**ADDENDUM NO. 03**  
**February 16, 2022**

To Drawings and Specifications dated February 2, 2022.

**FRIENDSWOOD HIGH SCHOOL ADDITIONS & RENOVATIONS**  
**FOR FRIENDSWOOD I.S.D.**

Prepared by: PBK  
11 Greenway Plaza, 22<sup>nd</sup> Floor  
Houston, TX 77046-1104  
PBK Project No: 20381

# A-101R

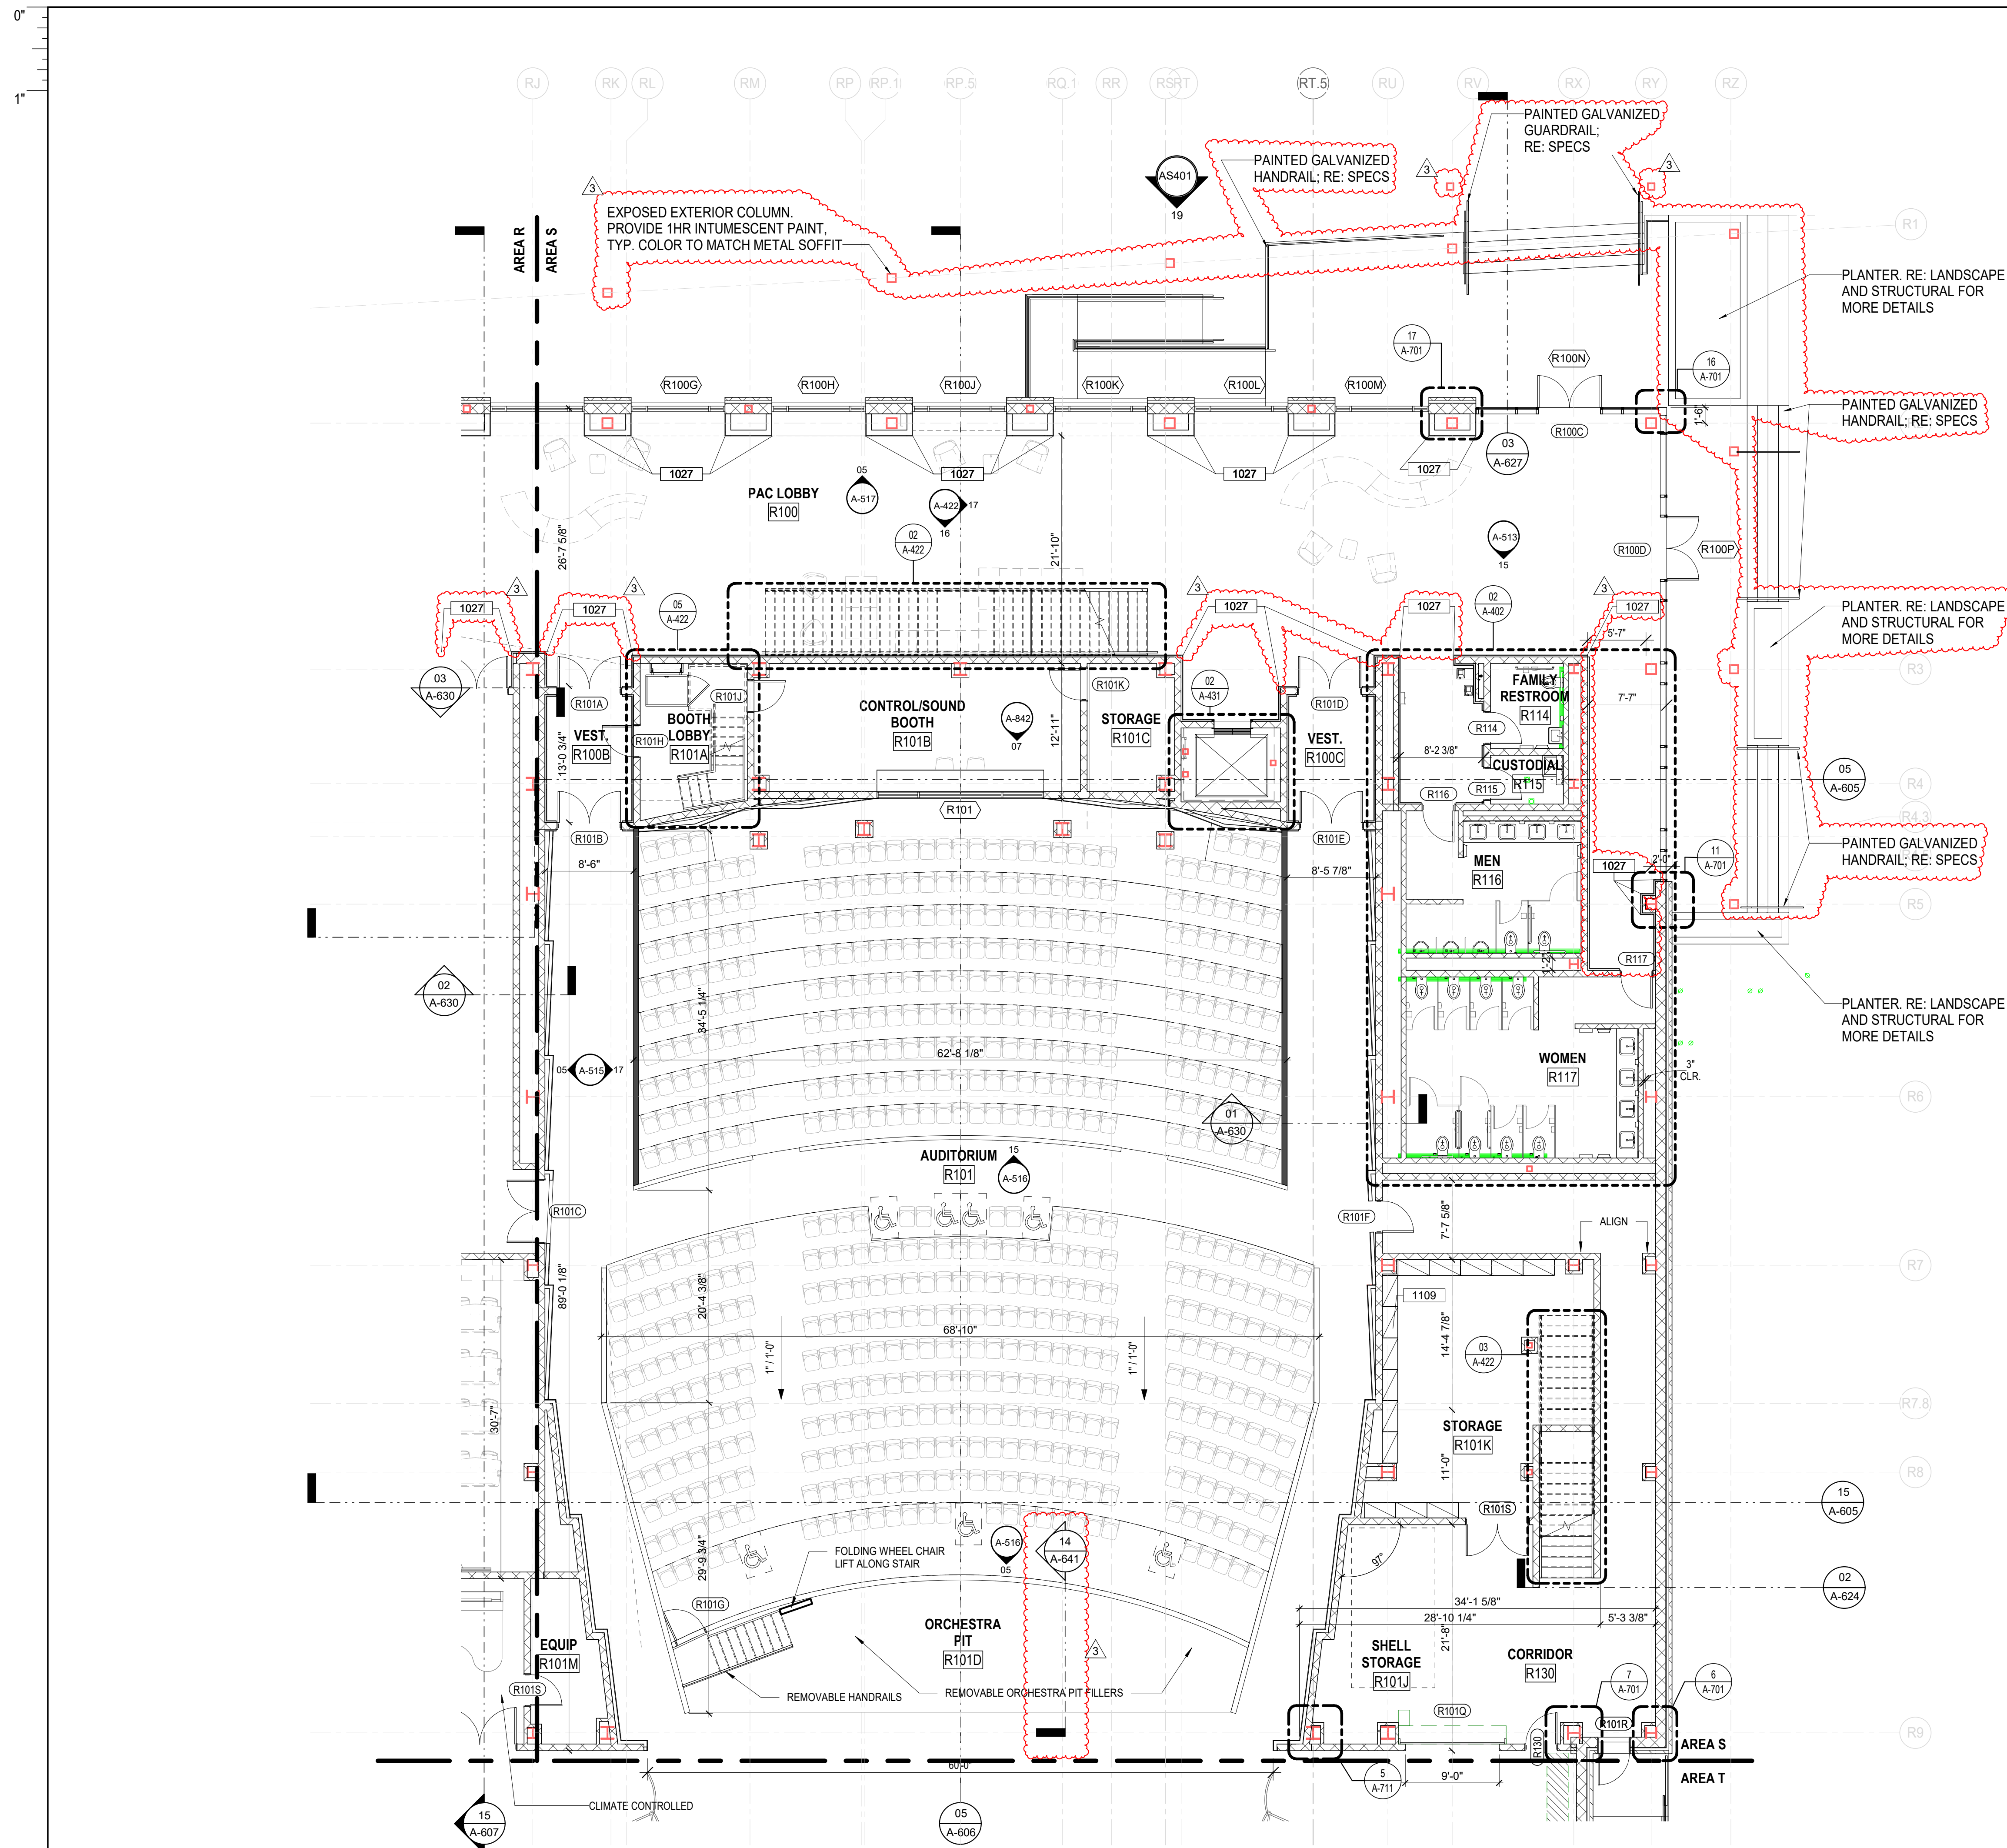
- Item No. 36 **I noticed that some of the frames on page A-101S are not labeled. I did see that they are in line with frames on A-101R and seem to be the same to me. The frames in question are R100G, R100H, R100J, R100K, R100L and frame R100M. I needed to know if these would be aluminum frames or not.** Answer: They are aluminum storefront window system.

- Item No. 41 **The Project Manual includes Spec Section 07 81 23 – Intumescent Fireproofing. Where is this required in lieu of sprayed fireproofing?** Answer: At the Performing Arts Center and Gymnasium lobbies where the columns exposed. Also, use at the Performing Arts Center exterior canopy columns – refer to sheet A-101R and A-101S.

# 01 1ST FLOOR PLAN AREA T - SET SHOP 1/8" = 1'-0"

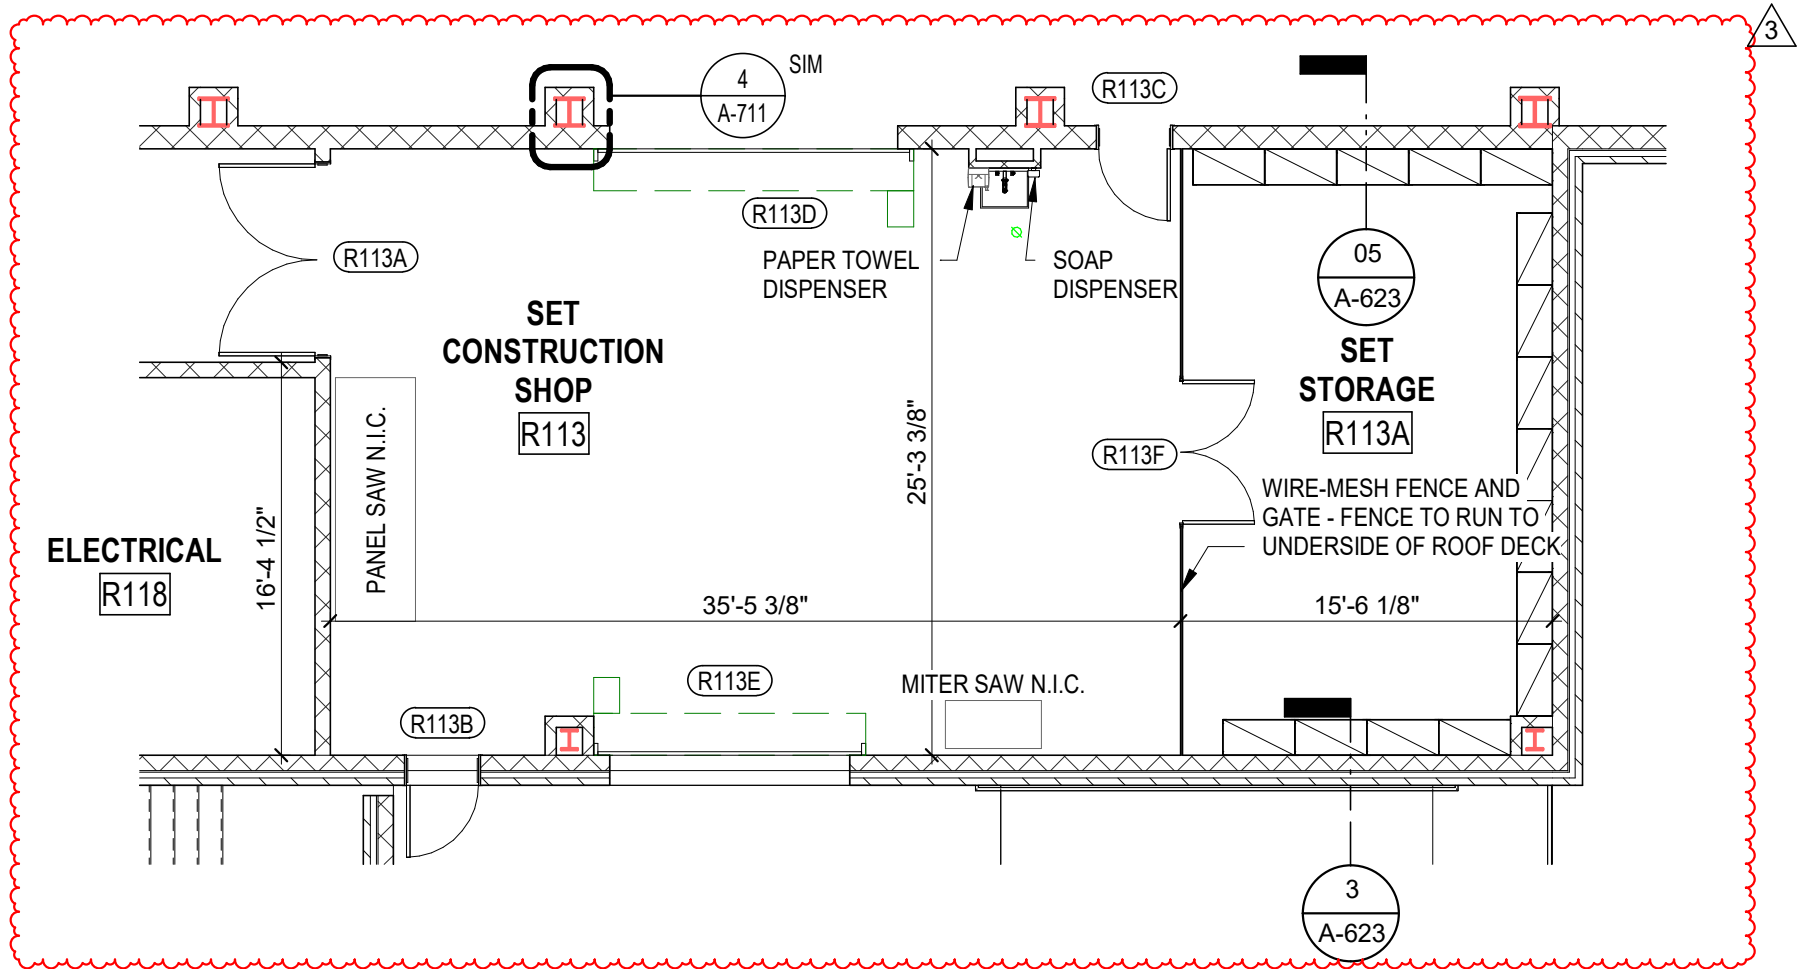
- Item No. 4      **Sheet A-101R:** Replace sheet in its entirety.
- Item No. 5      **Sheet A-101S:** Replace sheet in its entirety.
- Item No. 6      **Sheet A-101T:** Revise Set Construction Shop layout to show equipment. Refer to SK-01.

**SK-02**

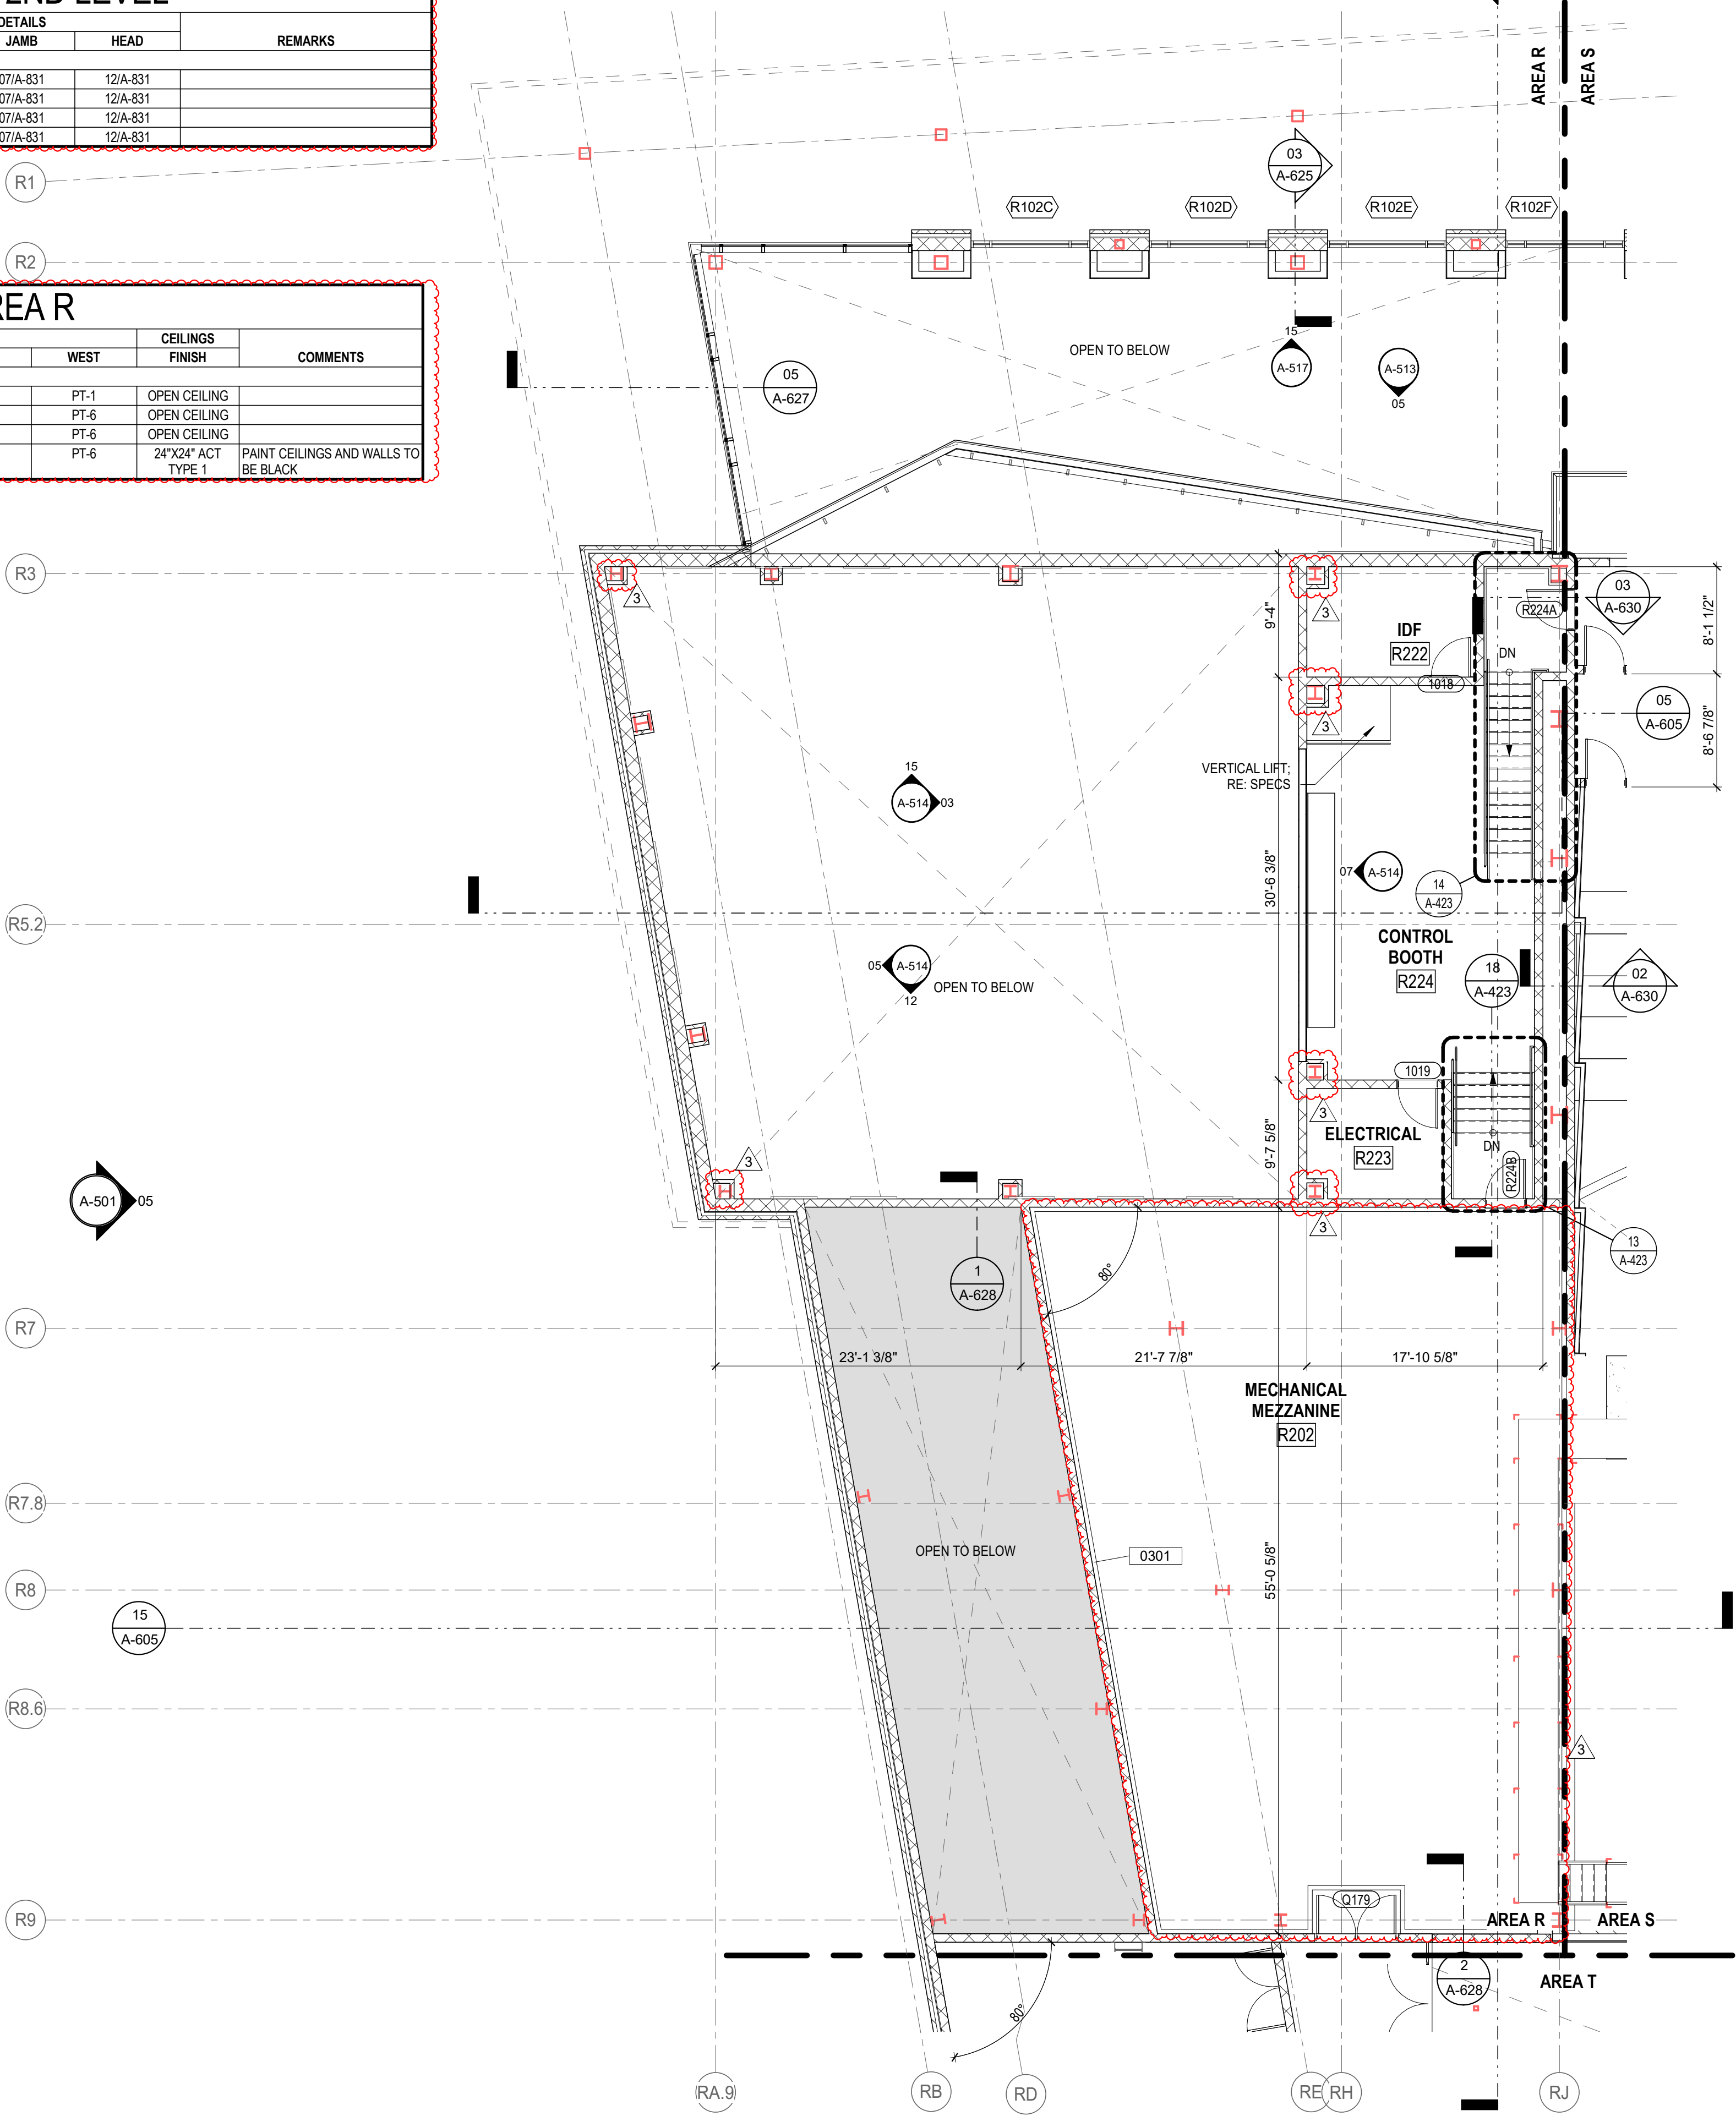
- Item No. 7      **Sheet A-102Q:** Revise Concessions plan to accommodate mechanical chase wall. Refer to SK-02.
- Item No. 8      **Sheet A-102R:** Replace sheet in its entirety.
